MTX / Soundcraftsmen	
SCALE:	APPROVED BY:
DATE: 10/12/92	DRAWN BY: MIKES
PRO INPUT BOARD: A200/400P	
BOARD # 45320081	
DRAWING NUMBER 2008

A200 & A400 PRD INPUT BOARD MODS

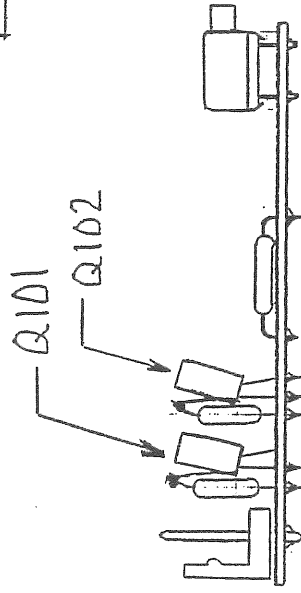
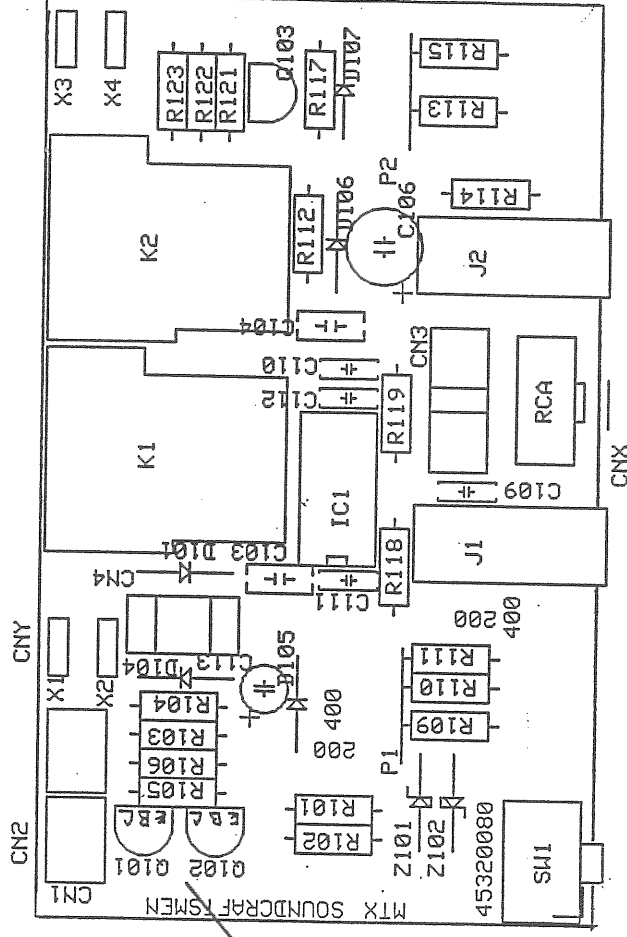
Add a resistor to the
COLLECTOR OF Q101 & Q102.

ON the A200PRD resistor
VALUE = 3.9K 1/2 W.

ON the A400PRD resistor
VALUE = 2.2K 1/2 W.
